London 2012 Olympic Park

Follow-on Project (Stage 2) Consolidated Validation Report – Planning Delivery Zone 1

December 2012

- Appendix A: Glossary of Terms and Definitions
- Appendix B: Schedule of Key Documentation (including summary of contents)
- Appendix C: Key Parties
- Appendix D: Permit to Proceed Protocol (CD only)
- Appendix E: Supporting Information
- Appendix F: PPDT / Hyder Document Review Comments and Responses

Drawing Title
**Figure 2 Olympic End Use
For Planning Delivery Zone 1**

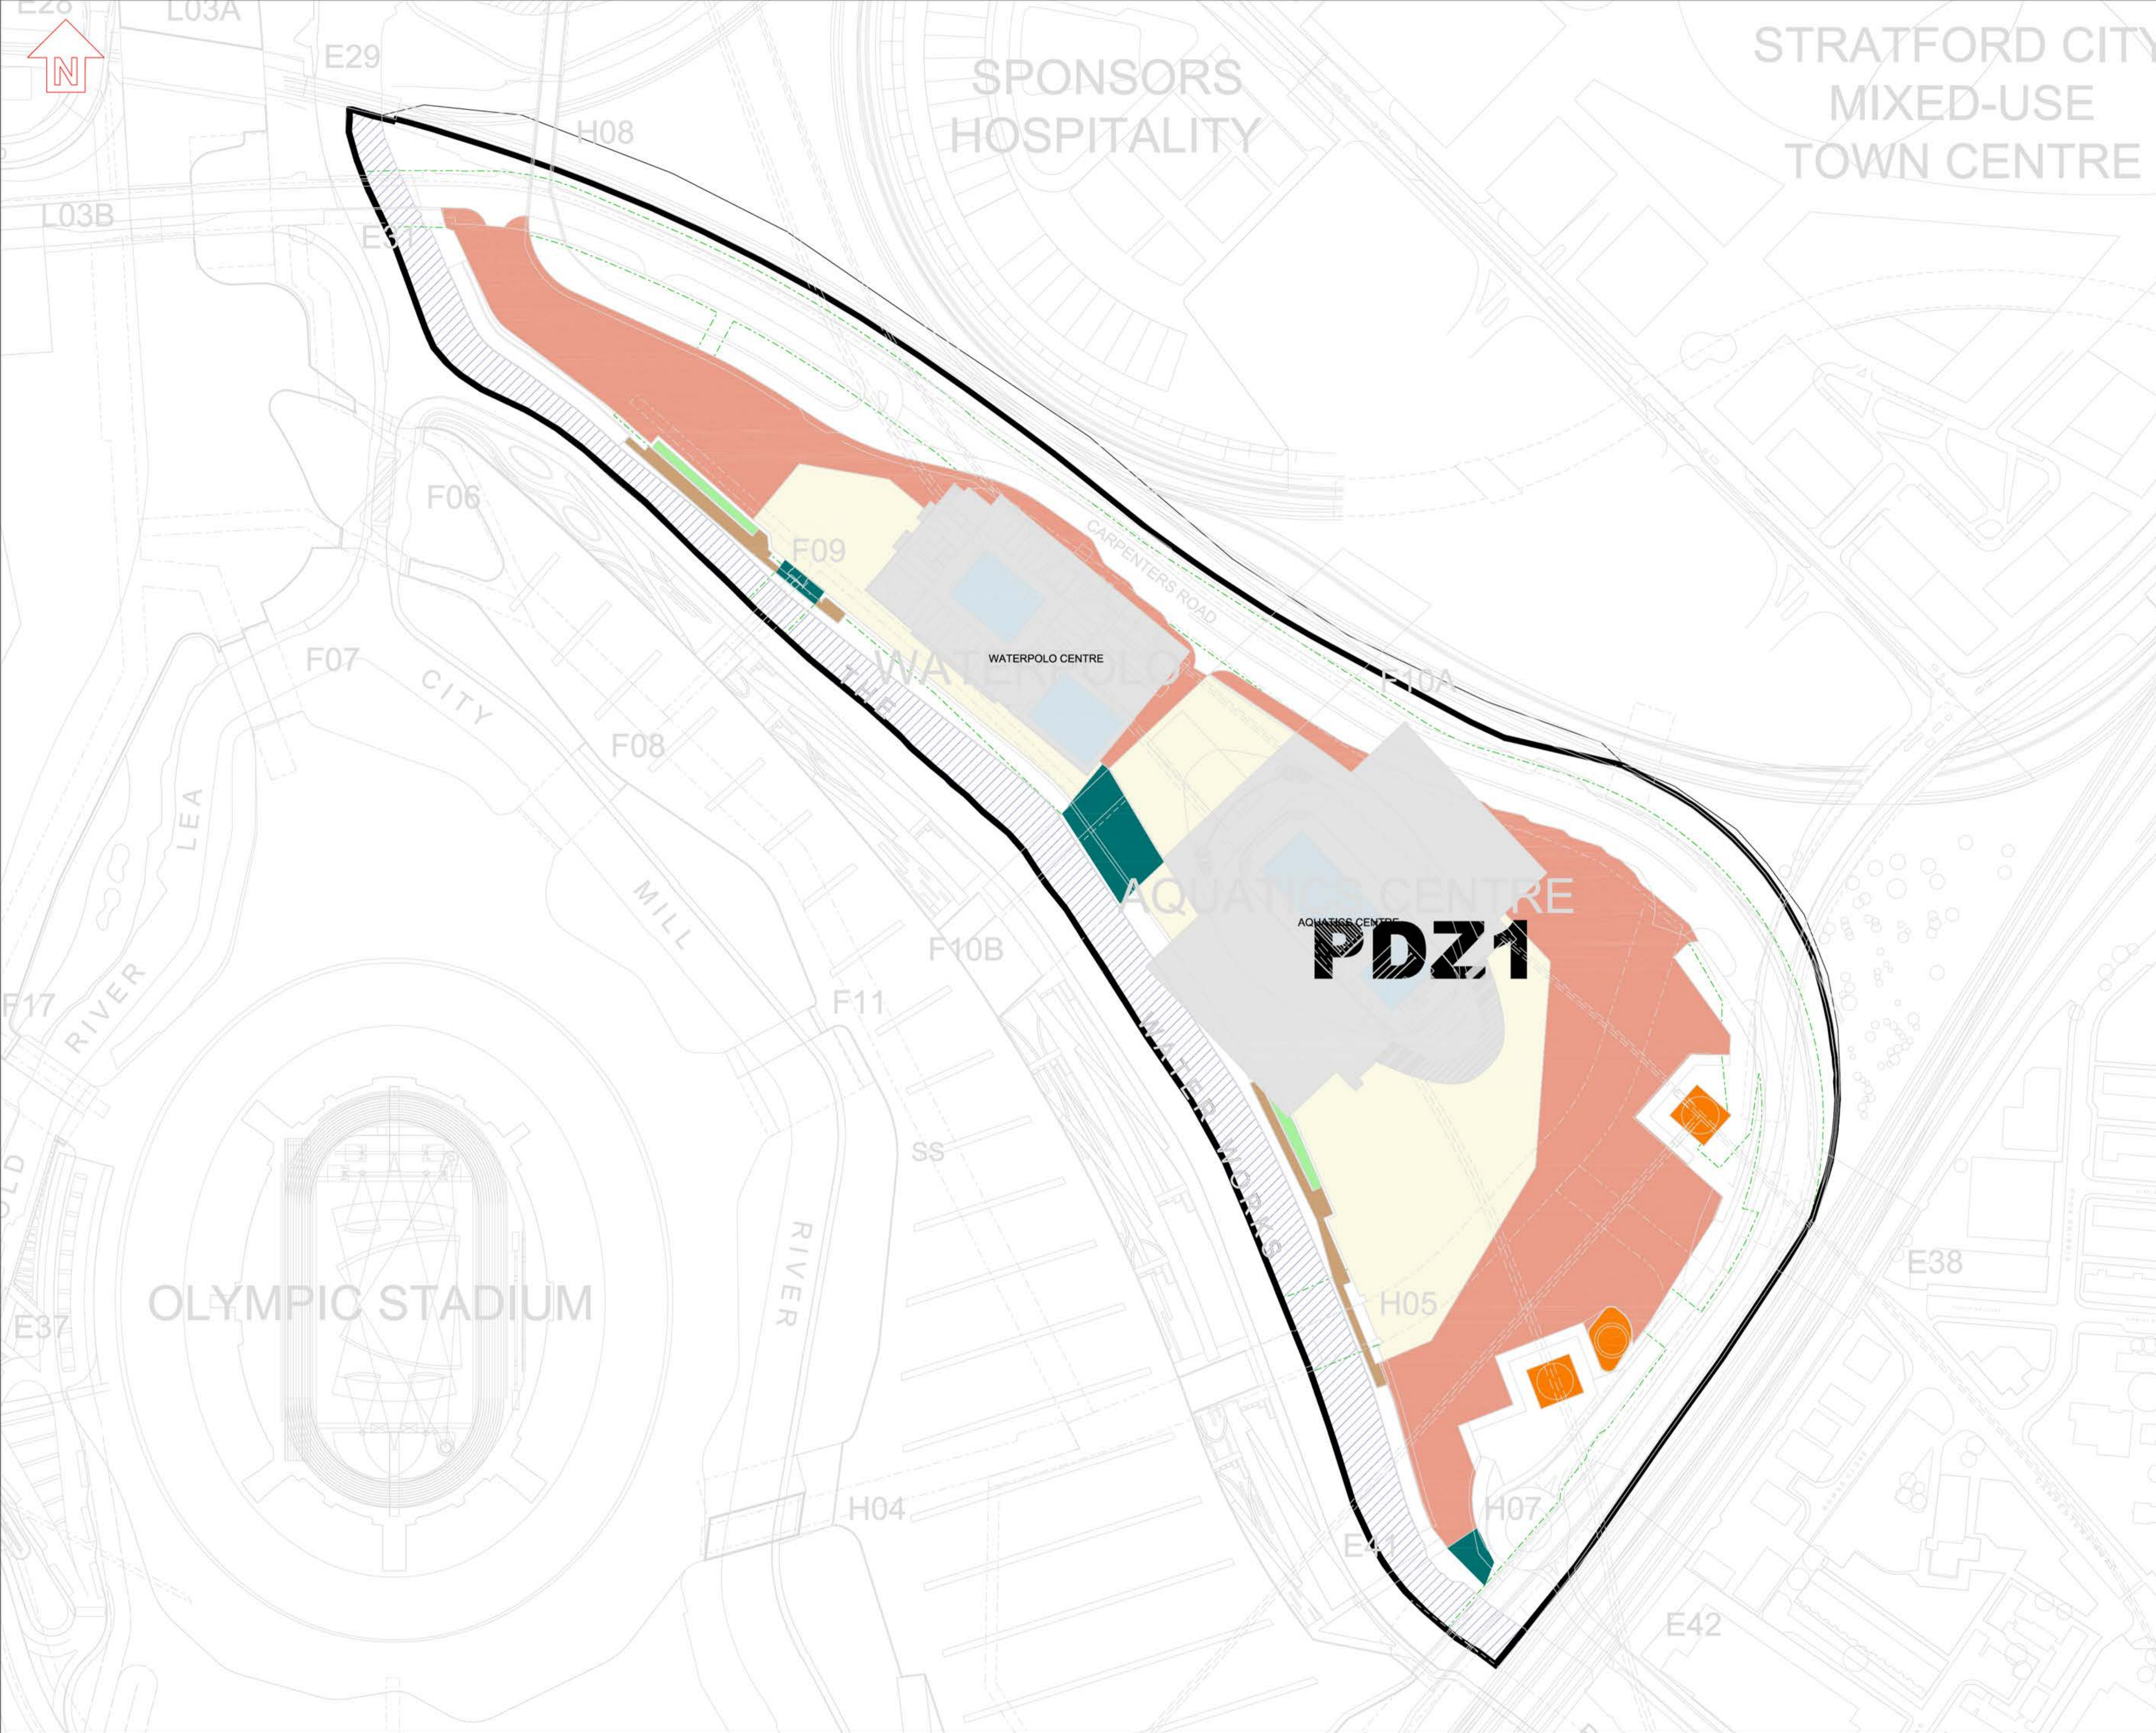
1.17	Figure 2 Olympic End Use For Planning Delivery Zone 1	The key and presented Figure indicate a number of 'unallocated areas' – please confirm what these relate to and whether they have been validated as part of the FOP works.	Response 03/12/12: This legend note has been carried over from the original SSRS Drawing and is no longer applicable. The note has been removed on the latest drawing version. Hyder 06/12/12: The legend has been updated by way of removal of "unallocated areas". Assuming the now unlabelled blank areas are in line with the SSRS and do not represent sensitive land uses, then no further comment.

1.18	Figure 2 Olympic End Use For Planning Delivery Zone 1	PPR – please could this be written out in full.	Response 03/12/12: 'PPR' or Parklands and Public Realm has been spelt out in the legend on the latest drawing version. Hyder 06/12/12: No further comment.

Drawing Title
Figure 3 Legacy End Use for Planning Delivery Zone 1

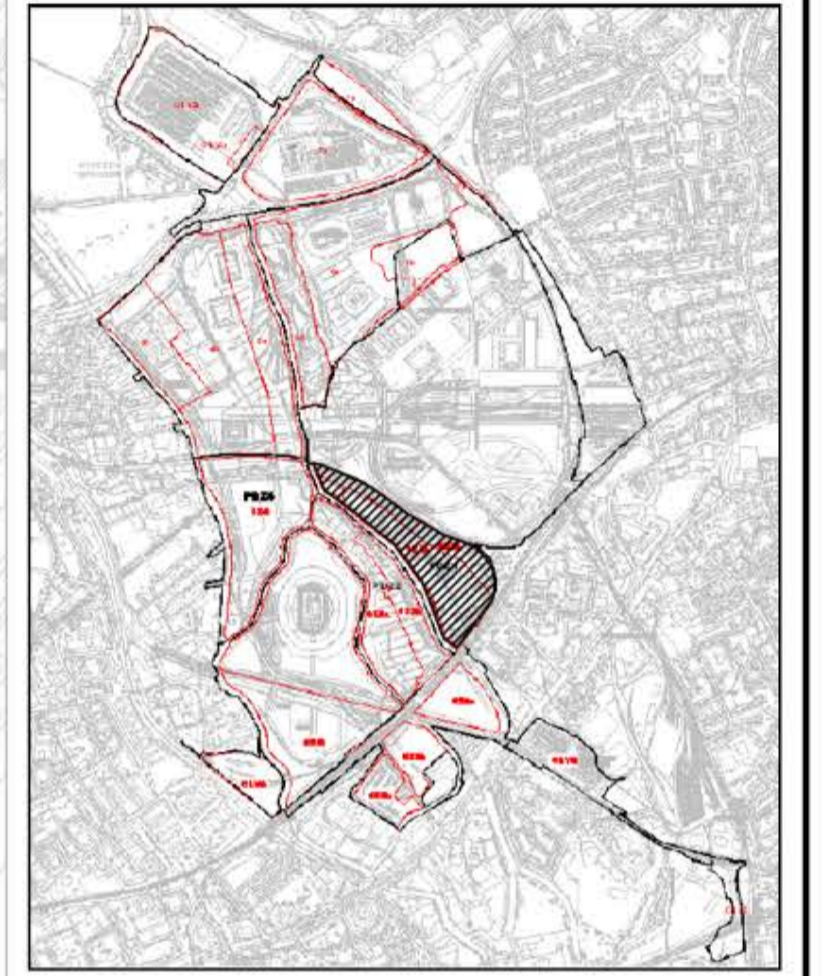
1.19	Figure 3 Legacy End use for Planning Delivery Zone 1	The key does not appear to be reflective of the actual drawing – please could you clarify / update the drawing.	Response 03/12/12: The drawing has been updated so the key better reflects what is actually shown. Hyder 06/12/12: No further comment.

1.20	Figure 3 Legacy End use for Planning Delivery Zone 1	There are a number of unmarked grey areas as well as the Waterpolo Centre. Is this correct?	Response 03/12/12: The drawing has been updated to better reflect the known Legacy use. Hyder 06/12/12: No further comment.

Drawing Title
**Figure 4
Spatial Coverage of FoP Validation Reports
for Planning Delivery Zone 1**

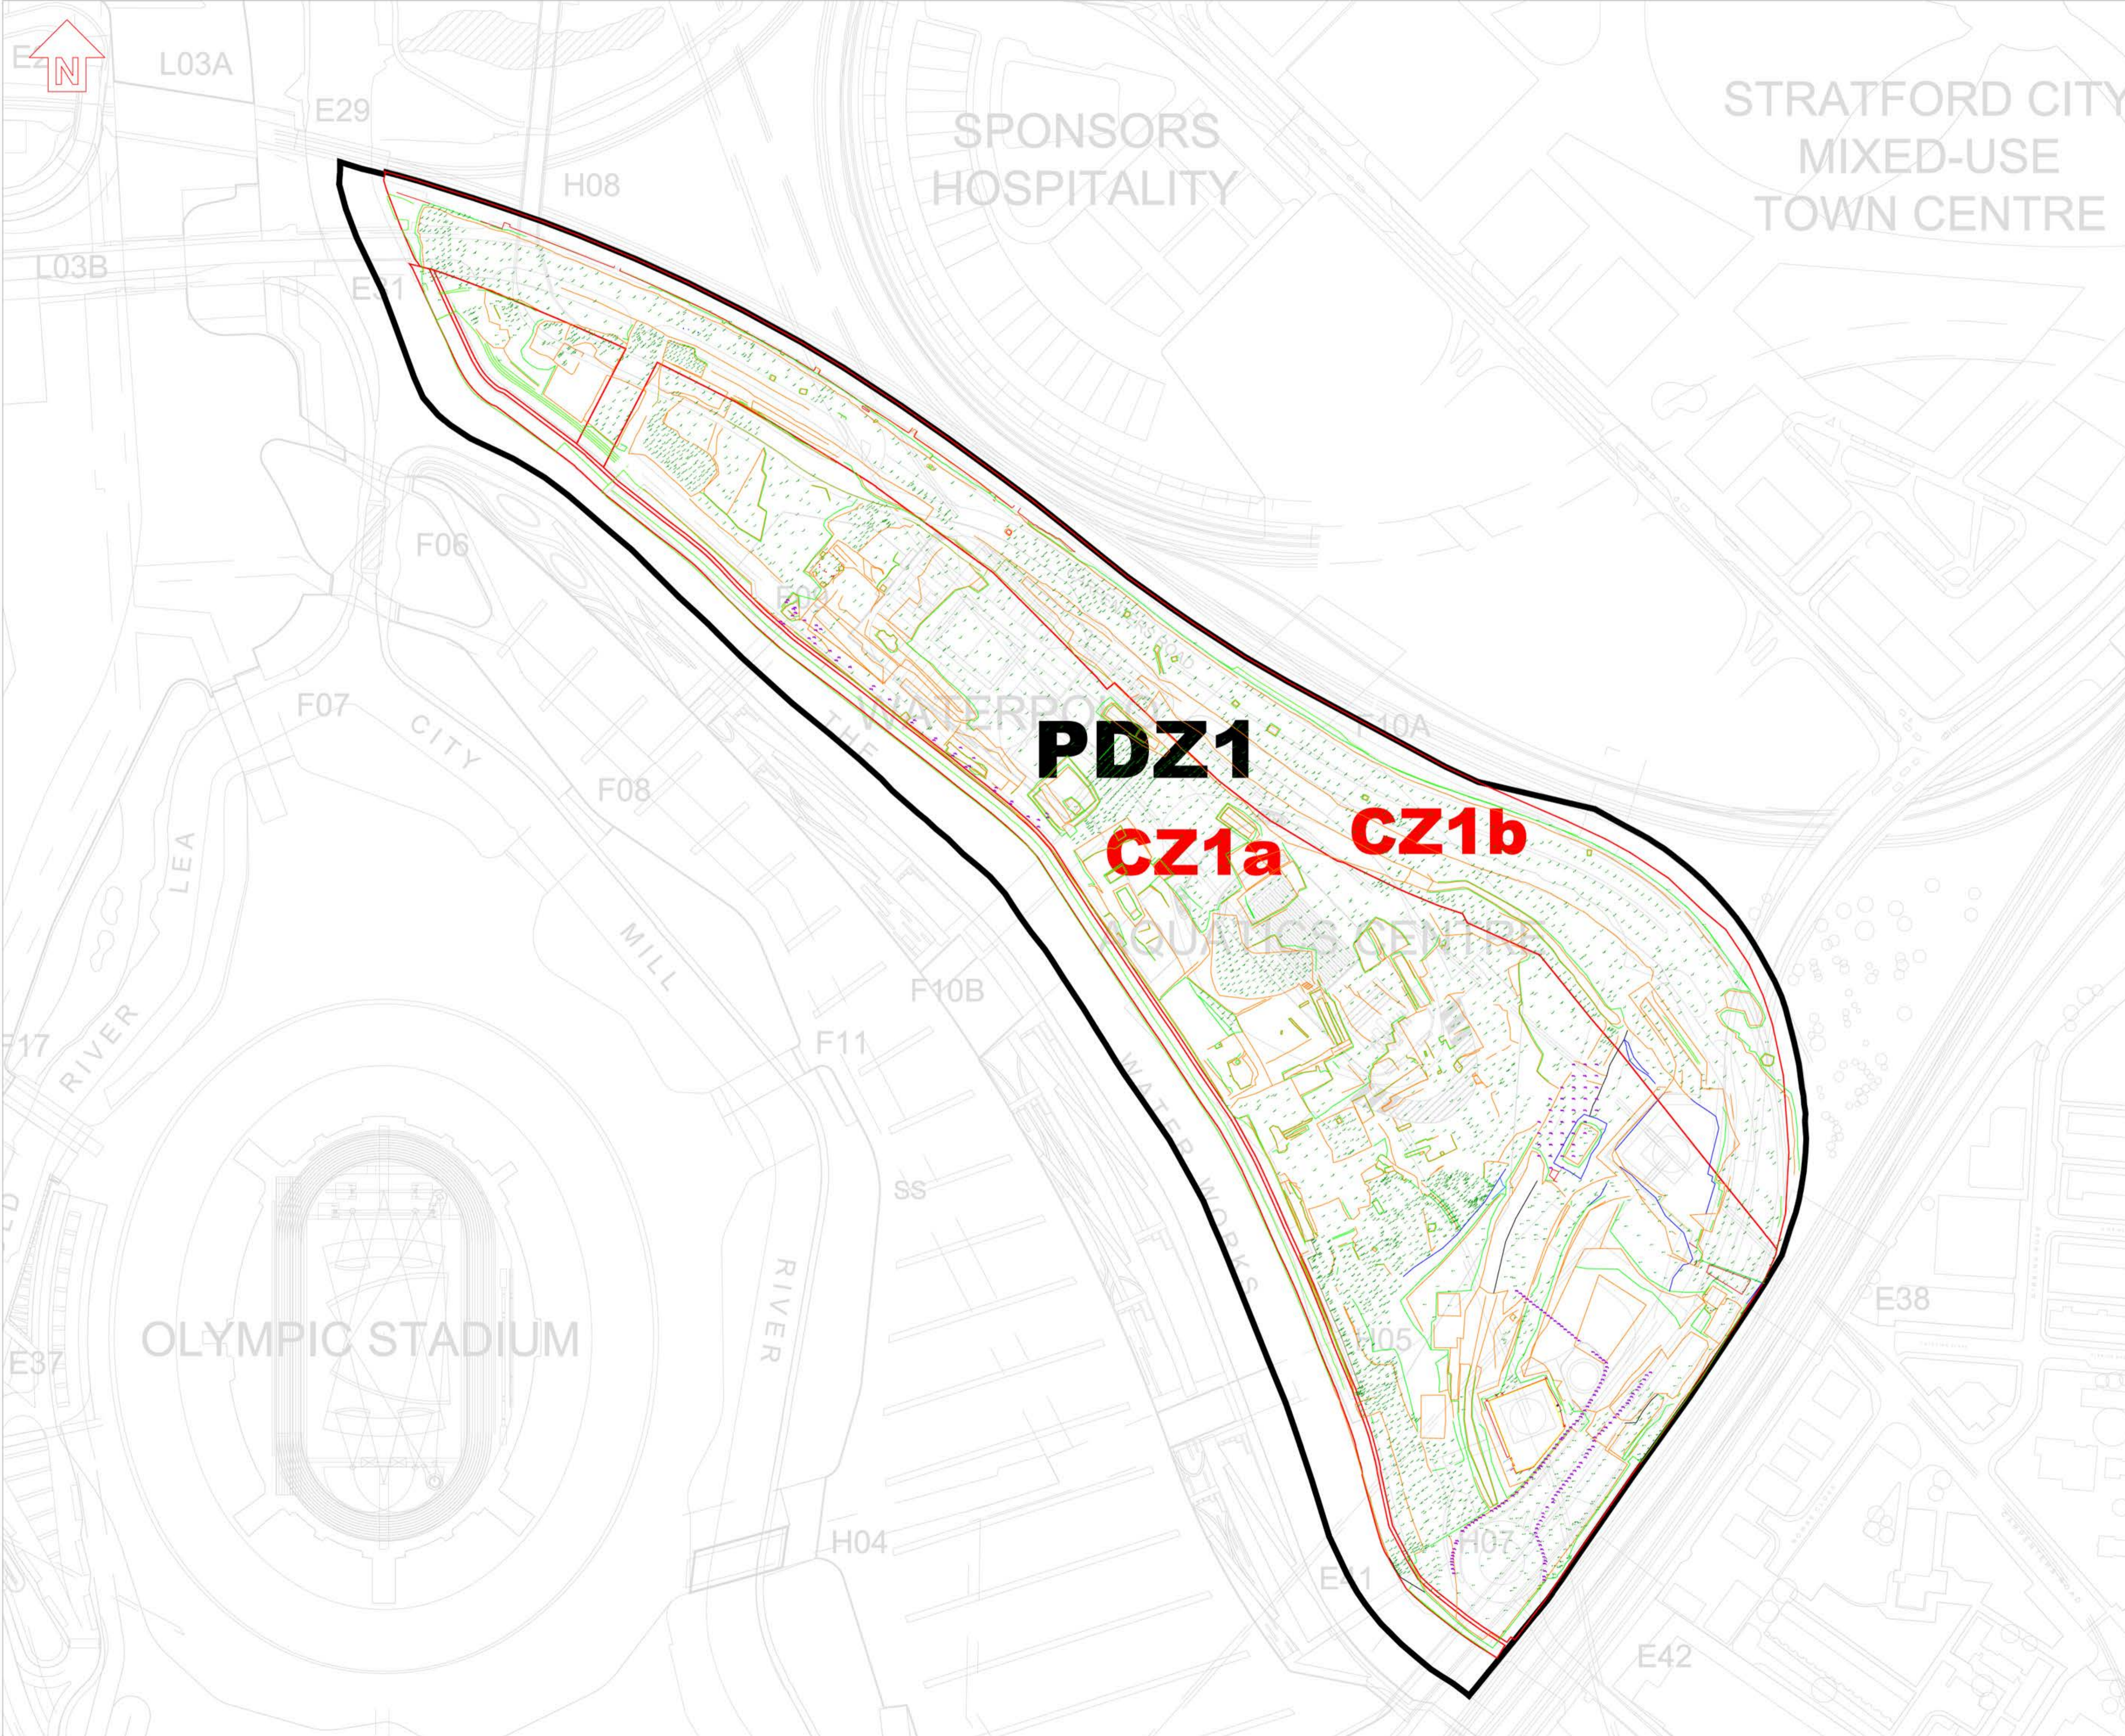
1.21	Figure 4 Spatial Coverage of FoP Validation Reports for Planning Delivery Zone 1	The drawing shows a number of 'blank' areas where no validation works appear to have been completed. Have these areas undergone validation? Are they RARAR areas? For completeness we suggest the figure explains why some areas are intentionally blank, if this is the case, even though they are within the PDZ boundary.	Response 03/12/12: The drawing has been reviewed and certain previously 'blank' areas have now been filled in. Where areas have not been subject to validation a legend note has been included to denote these and a further note directs the reader to the RARA areas as shown on Figure 9. These changes are consistent with those agreed for PDZ2. Hyder 06/12/12: Figure 4 has been updated in line with the above including addition of a note. No further comment.

Ref.	Submission Section / Aspect	HCL Comment	Applicant's Response
1.22	Figure 4 Spatial Coverage of FoP Validation Reports for Planning Delivery Zone 1	<p>FoP Validation Reports Table:</p> <ul style="list-style-type: none"> Jackson Water Polo Report – please check the report reference, this is different to that given in Appendix B. McNicholas Multi Utilities Report – please check the Decision Notice – it is different to that given in Appendix B. Cofely report – we are unable to find this in Appendix B, please could you clarify and update accordingly. 	<p>Response 03/12/12: The drawing Table and Appendix B have been updated to account for the following changes:</p> <ul style="list-style-type: none"> BH / Jacksons Water Polo report – Appendix B reference amended; McNicholas Multi-Utilities – Decision ref. amended in the drawing Table; Cofely report – this does not relate to PDZ1 and reference has been removed from the drawing. <p>Hyder 06/12/12: No further comment.</p>

1.23	Figure 4 Spatial Coverage of FoP Validation Reports for Planning Delivery Zone 1	Are there intentionally blank areas?	<p>Response 03/12/12: Certain areas have not been subject to ODA FoP validation and have been left blank – refer to response to comment 1.21 above.</p> <p>Hyder 06/12/12: No further comment.</p>
